Tanker Q&As and CIs on the IACS CSR Knowledge Centre

KC#203

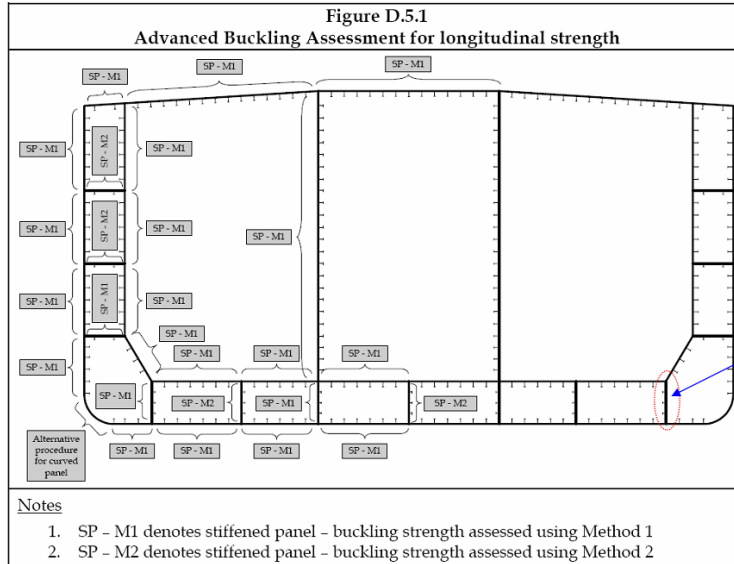
203 attc	D/5.2.3.2	CI	plate breadth	2006/11/28	Figure 5.6, Note It is unclear that modification of plate breadth can be applicable provided that the web/collar plate is to be attached to the both sides of the passing stiffener or only one side of it. Please clarify the applicable of the modification of plate breadth.	The note to Figure D.5.6 states that the modification of plate breadth is applicable provided that the web is attached to the passing stiffener. Hence, it is not required that the web need to be attached to both sides of the stiffener.	Y
267	D/5.2.3.2	Question	buckling	2007/1/3	A) D/5.2.3.2 text on reason for use of figure D.5.6 implies that Fig D.5.6 is only used for cases where advanced buckling method cannot model the panel geometry and only for un-stiffened panels. This is not correct. B) In application of D/5.2.3.2 it should be clarified if the peak stress on the short edge of Fig D.5.6 is based on the value where the web attaches to the bulkhead plate OR based on the value by interpolation corresponding to the height $h_{stf}/2$. C) The application of Fig D.5.6 should also be applied to SP-M2 type.	a) Your comments are noted and agreed. We will update the Rules so that Figure D5.6 also covers panel edge restraint (as well as panel geometry) and stiffened panel (as well as un-stiffened panel). b) The idealization in Figure D.5.6 give some credit to the panel due to the "strong" edge constraints from stiffener by shortening the panel width. Stress is always taken from the centroid of each element within the panel and then take stress average accordingly to D/5.3.2.1. There is not interpolation that any particular high stress spot taken into consideration. We intend to update the Rules to make this clear. c) Yes. This will be taken care by the Rule update in a).

Case 1

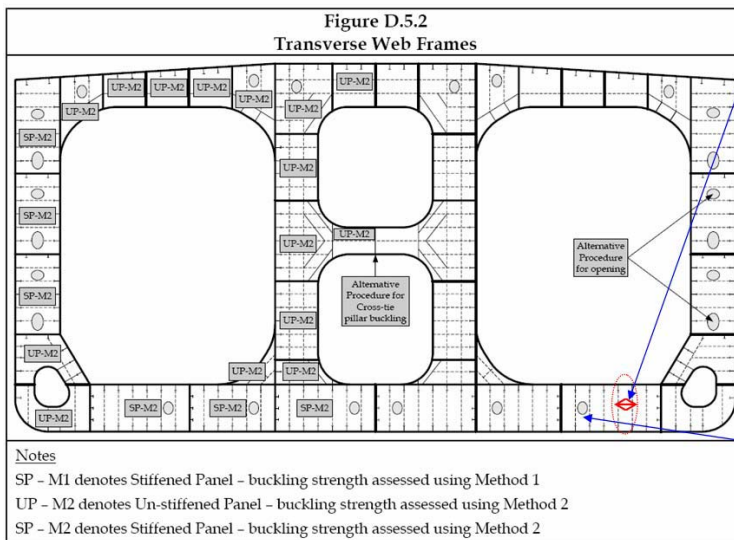
1.1
In case of snipped stiffener is applied at side girder, which method should be applied?
SP-M1 with snipped stiffener, SP-M2 with snipped stiffener, UP-M1 or UP-M2 ?

704 attc	App.D Table D5.1	Question	Buckling methods in the cases 1.1,2.1-2.3 and 3.1-3.2	2008/8/29	Please clarify application of advanced buckling methods in the cases 1.1, 2.1-2.3 and 3.1-3.2 as shown in attachment .	The reply refers to index used in attachment to the question: 1.1 SP-M1 2.1 SP-M2 with secondary stiffeners perpendicular to regular stiffeners. 2.2 Yes (SP-M2) 2.3 Buckling assessment in way of openings to be carried out according to 10/3.4 3.1 SP-M1.	Y

Case 2

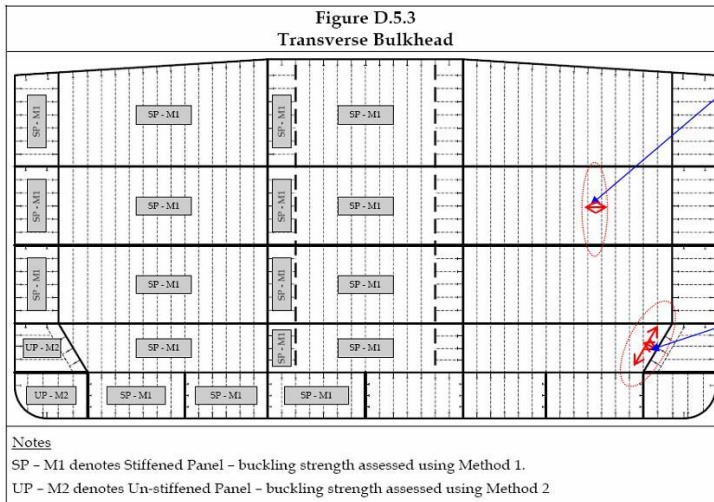
2.1
In case of additional buckling stiffener is applied at floor. Which method should be applied?

2.2
And other buckling panels at the same stiffened panel SP-M2 with stiffener number of 6 is acceptable?

2.3
If opening is not modelled and net thickness is recuded based on Table B.2.2 in App2.
How to do buckling assessment with this buckling panel?

Case 3

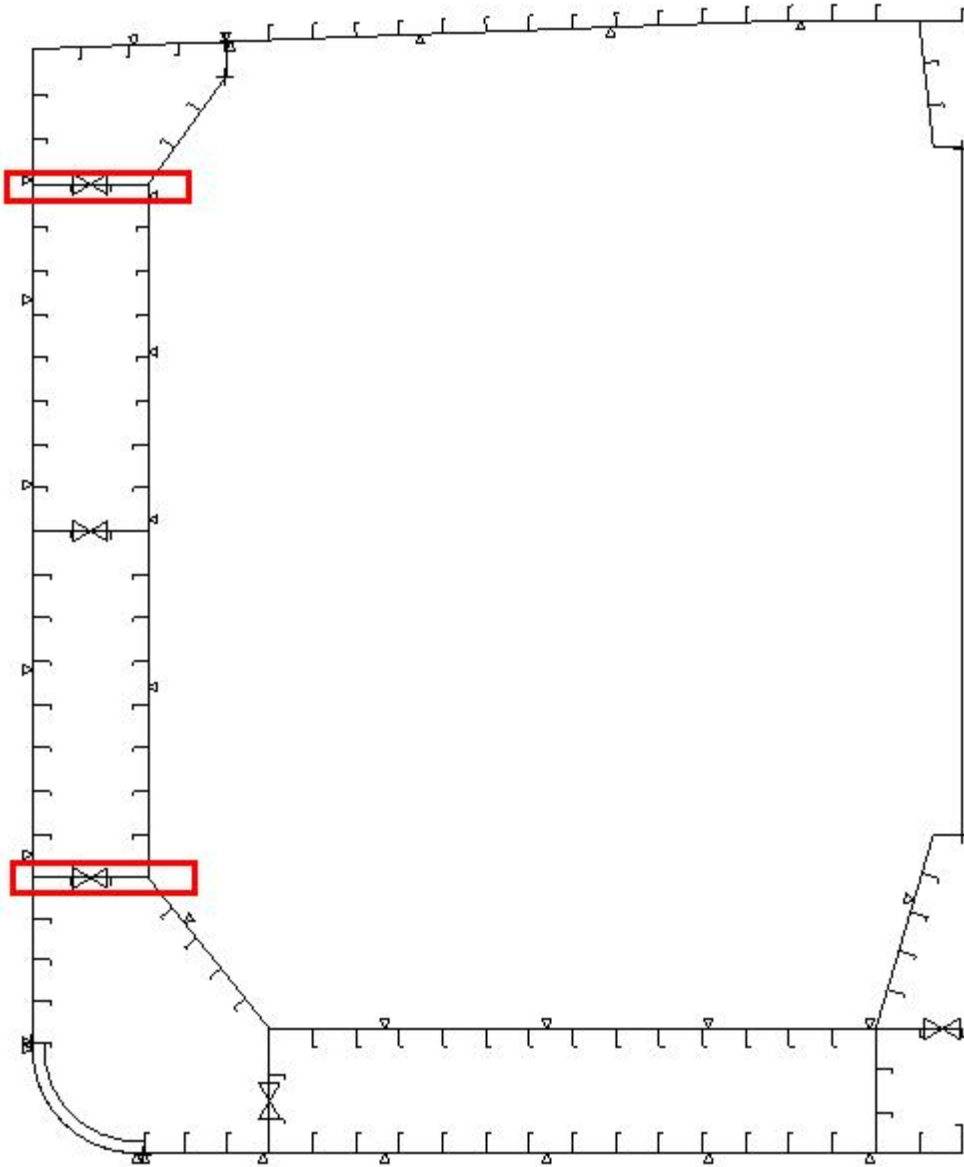
In case of additional buckling at Bulkhead. Which method should be applied?

SP-M1 with secondary stiffener , UP-M2 or UP-M1 ?

If stiffener is installed as shown, which method should be applied?

SP-M1, UP-M2 or UP-M1 ?

KC#890

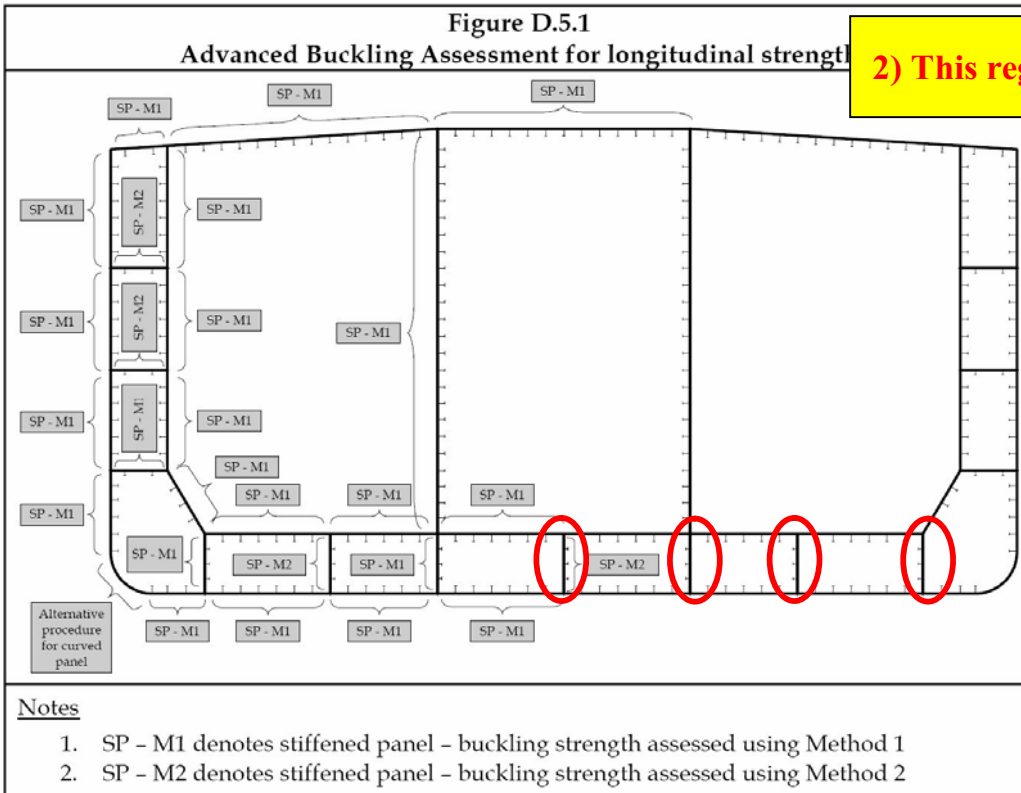
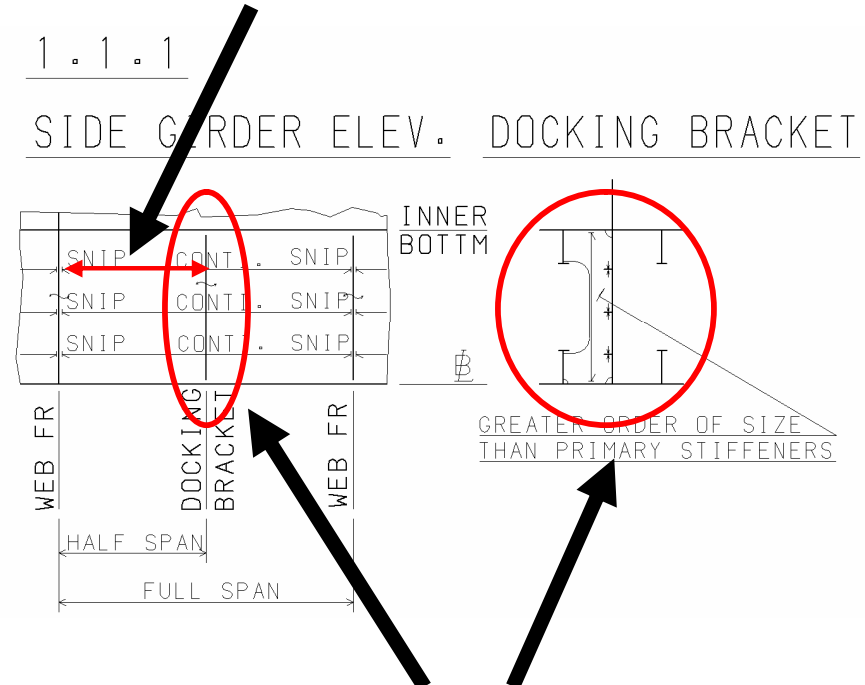
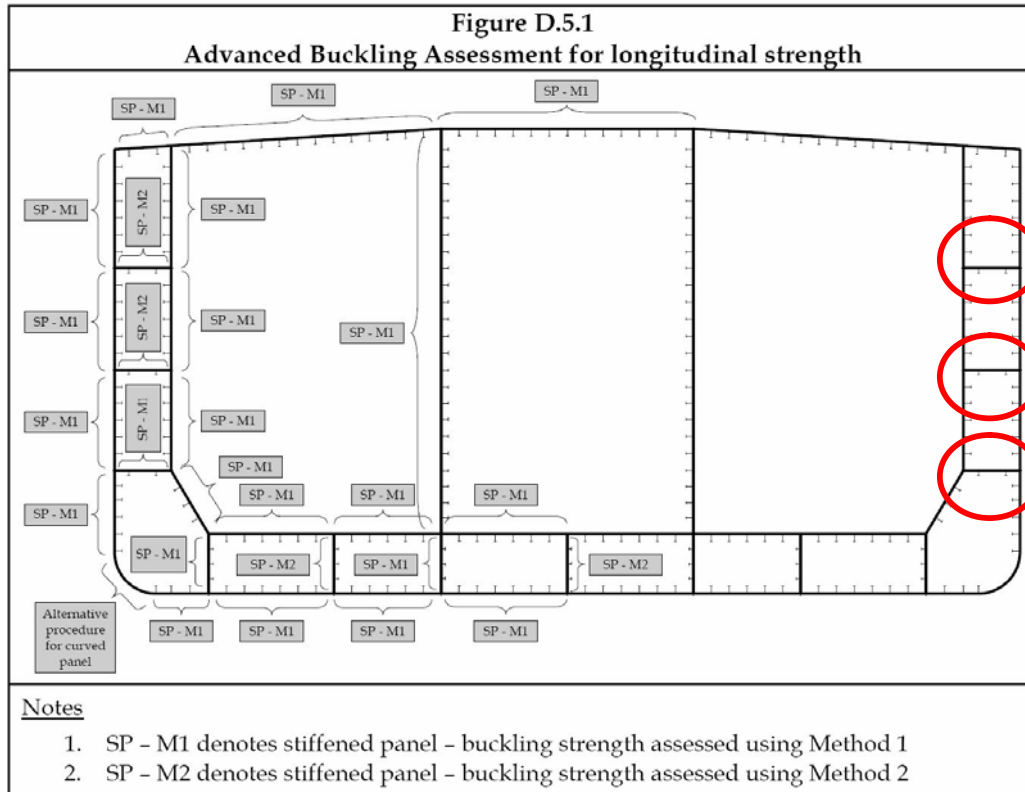
KCID No.	Ref.	Type	Topic	Date completed	Question/CI	Answer	Attachment
890 attc	Fig D.5.1	Question	horizontal girder	2009/3/25	In case of the vessels without topside tank, Figure D.5.1 says that assessment method 2 (SP-M2) is to be applied to upper horizontal girder in double side. However, for the vessels having topside tank such as chemical tanker (please see the attached figure), assessment method 2 (SP-M2) is still to be applied to upper horizontal girder connected to slanted top side plate of inner hull? Considering the geometric shape of the upper horizontal girder is similar with lower horizontal girder connected to hopper tank side, I think it is possible to apply assessment method 1 (SP-M1) instead of method 2 (SP-M2) to the upper horizontal girder. Please clarify.	Assessment method 1, SP-M1 is to be used for the upper horizontal girder in this configuration	Y
940 attc	Table D.5.1	CI	Consideration of docking brackets for buckling assessment	2010/3/8	Docking brackets are generally attached to double bottom longitudinal girder of large oil tankers, e.g. VLCC. For the advanced buckling assessment of such a double bottom girder (please see the attached sketch); 1) should docking brackets be considered as a secondary stiffener? or a primary supporting member (PSM)? 2) in case primary support member is right, considering Note (3) in Table D.5.1, the regular stiffeners (i.e. longitudinal stiffeners on double bottom girder) should be considered as 'sniped'? Please clarify.	We would like to clarify as follows: 1) Docking bracket to be considered as a secondary stiffener 2) Regular stiffener to be considered as sniped	Y

2) This regular stiffener is to be considered as 'Sniped'? or 'Continuous' ?

1) Docking bracket is 'Secondary stiffener' ? or 'Primary supporting member' ?

1.1.2.1

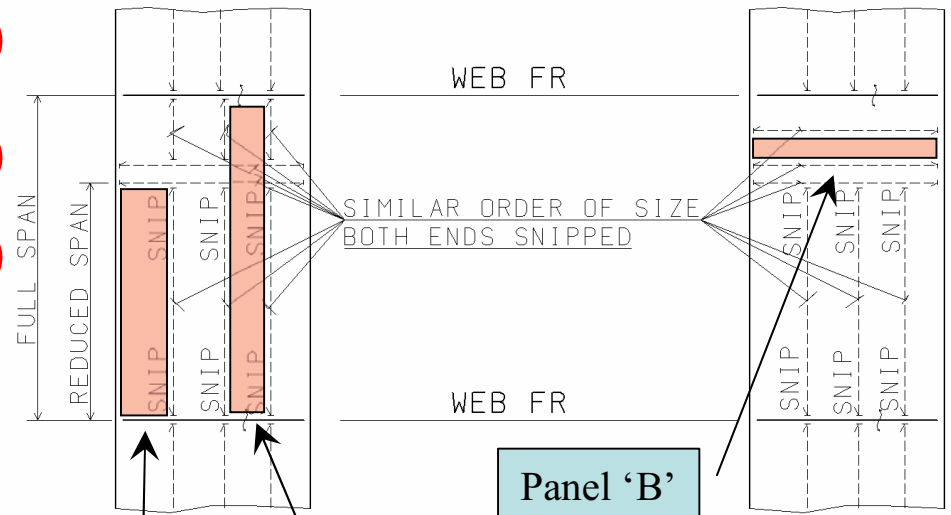
- 1) Is it OK to define a buckling panel like 'A1' ?
- 2) How about 'A2' ? Is it possible?
- 3) I think 'SP-M1' may be used for the panel 'A'(A1 or A2) and 'UP-M2' for the panel 'B'. Is it right?

941 attc	Table D.5.1	CI	Definition of buckling panel and buckling method for horizontal girder	2010/3/8	When defining buckling panel and buckling method for horizontal girder having special arrangement of stiffeners, such as the attached sketch ; 1) is it possible to define a buckling panel like 'A1'? 2) is it possible to define a buckling panel like 'A2' instead of 'A1'? 3) which buckling method may be applied to the panels in the sketch? Please refer to the attachment and clarify.	1) panel A1 is possible 2) panel A2 is not possible 3) 'UP-M2' for both panel A1 and B	Y
